NOLA DESIGN - TECHNICAL RESPONSE TO THE COMMENTS RAISED BY HAMPSHIRE COUNTY COUNCIL – Prepared by Rob Colins on 16/03/2023.

Lead Local Flood Authority response for F/22/93970 THORNEYDOWN FARM, MOORHILL ROAD, WEST END, SOUTHAMPTON, SO30 3AY

The following comments are made in response to the letter from Hampshire County Council in their capacity of Lead Local Planning Authority, to Eastleigh Borough Council, Reference SWM/2022/0579/; dated 11 November 2022.

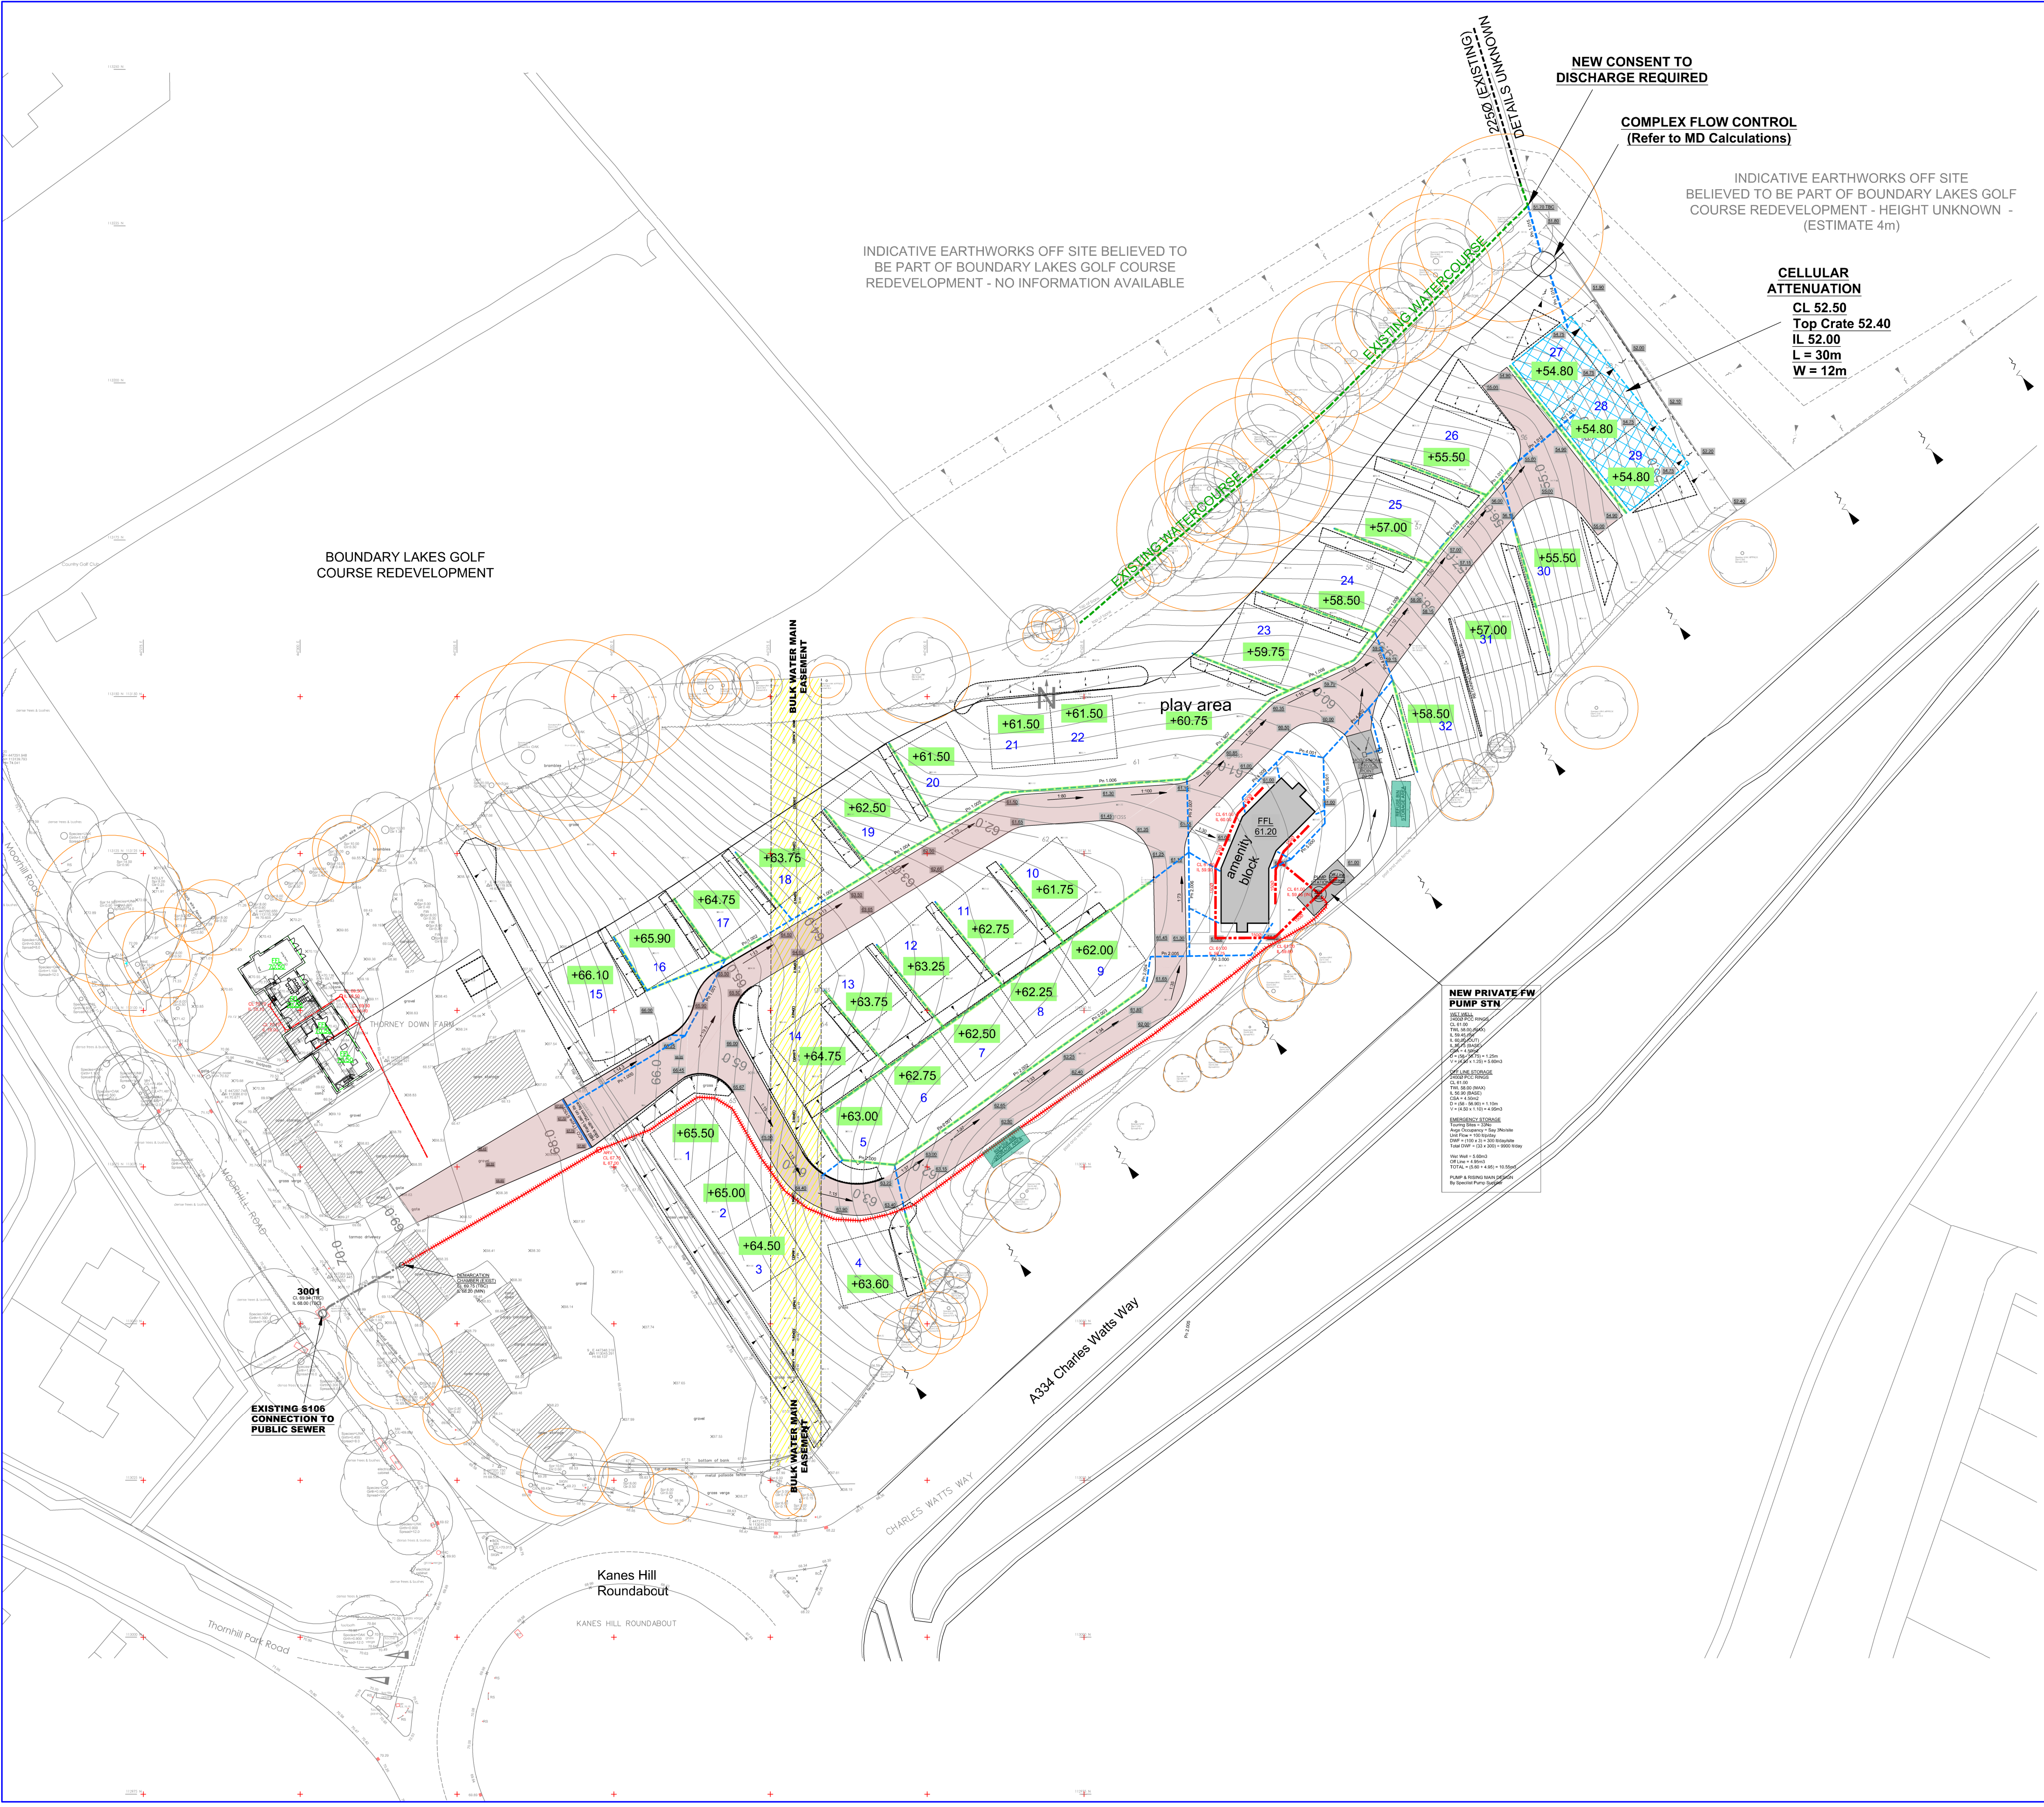
11. Connection to Existing Watercourse

Response - It is our Client’s intention to discharge flows from this development site into the existing watercourse which follows the northern site boundary.

Any Consent to Discharge into this watercourse will be obtained from the LLFA if permission is granted and this can be a condition.
